HSCC I Ltd

Amendment –XIV

Dated 15.02.2018

Tender Enquiry No: HSCC/SJH/Medical Equipment/35 Dated 18.10.2017

DRAWING No.: O13189 - A - HP - 01 - WD - 0014
SECTION: ELEVATION MARKING
SCALE: 1:125
PROJECTION: FIRST FLOOR PLAN - ZONE 2
SIZE: A1
NO.: 2

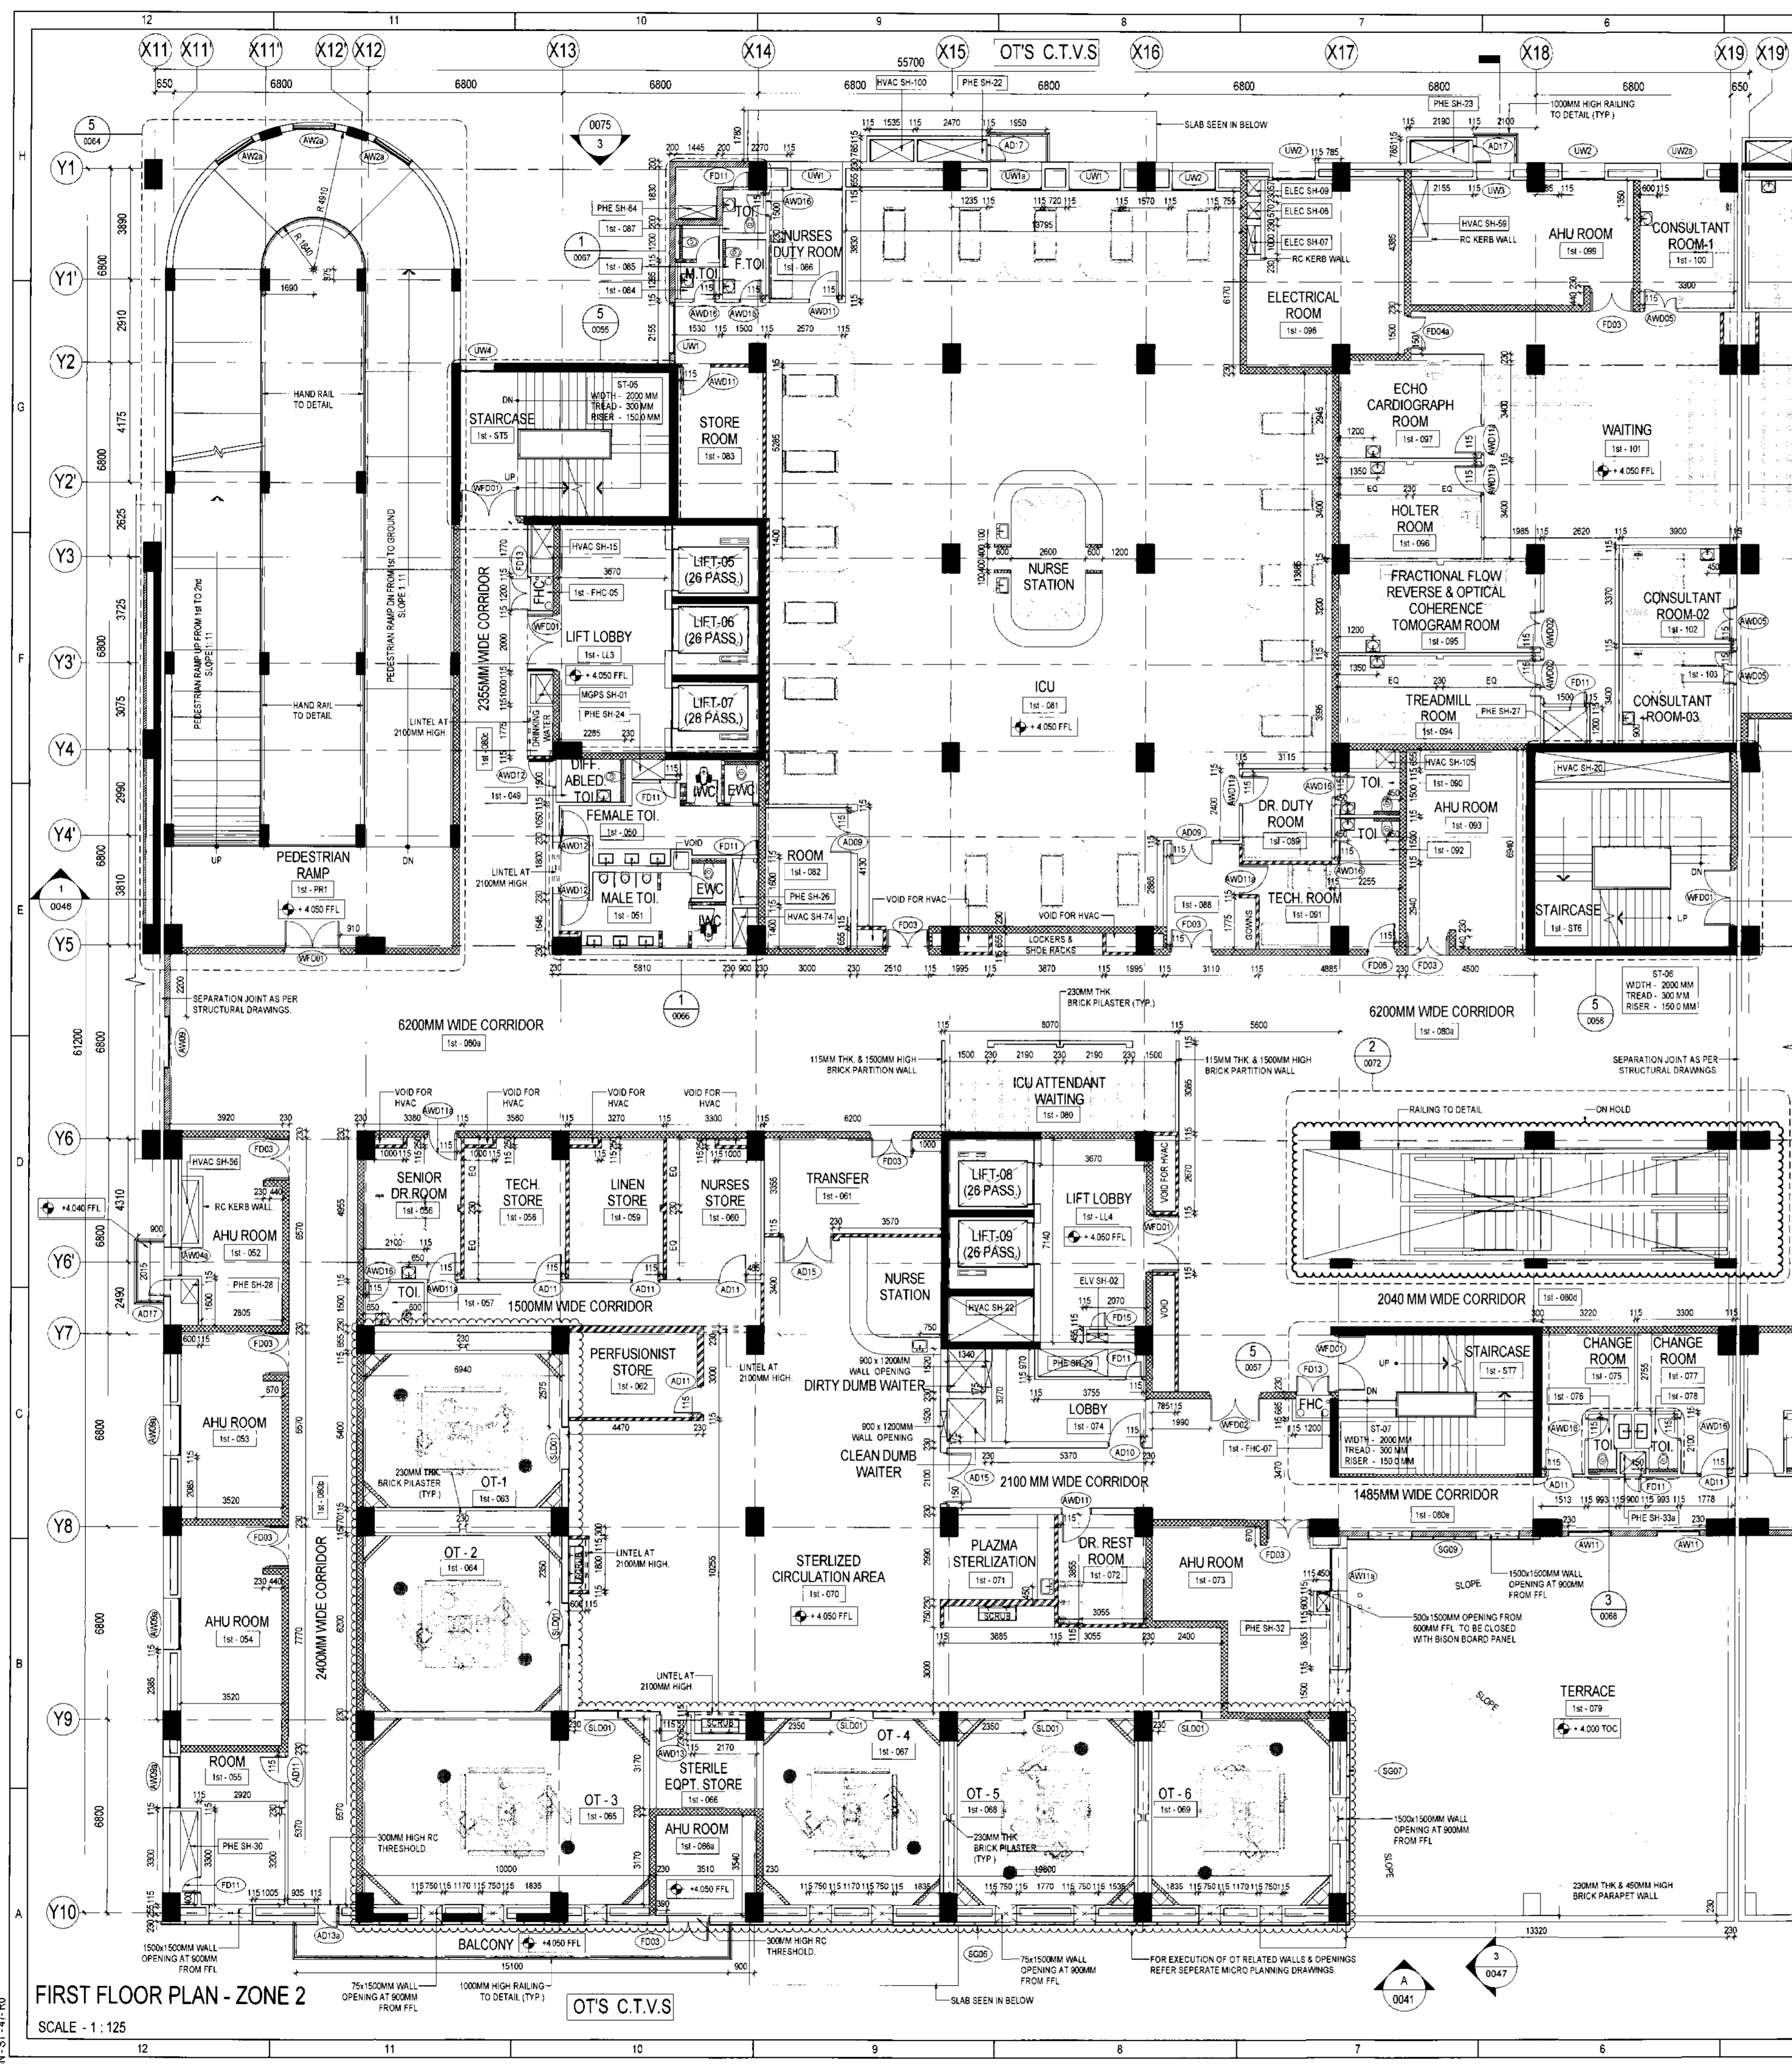
For Item No. 8, Angiography System for Interventional Hybrid Procedure, the technical amendment & Approved layout plan have been received. It is therefore extended from 16.02.2018 to 23.02.2018. for Item No.8 Angiography System for Interventional Hybrid Procedure and site layout plan are as under:

1. Area under the scope of the site modification is :-
 - o Examination Room
 - o Console Room
 - o UPS cum Cabinet room
2. Examination room should be in line with AERB requirements
3. Lead Glass window and lead door to be provided on console and examination room common wall. Second lead lined door to be provided in the examination room for patient entrance
4. PVC Flooring, trenches and cable trays to be provided.

5. Air-conditioning of 2 x 2 TR(Split AC) to be provided in the UPS cum cabinet room
6. Total load of the equipment along with the accessories to be mentioned by the vendor
7. Hospital authorities to provide electrical cable upto electrical panel in the UPS room
8. LT panel should be Supplied & installed by the vendor

9. All general lighting, electrical fittings and fixtures to be provided by hospital authorities
10. Adequate fire detection system to be provided by the vendor, inside the area under the scope mentioned above
11. Partition to be provided between UPS and Batteries in the UPS room
12. All civil works related to successful installation of the machine as per the layout attached should be carried out by the vendor
13. Wall finishes in console and UPS room - upto fall ceiling skirting along with POP and plastic emulsion paint upto the false ceiling.
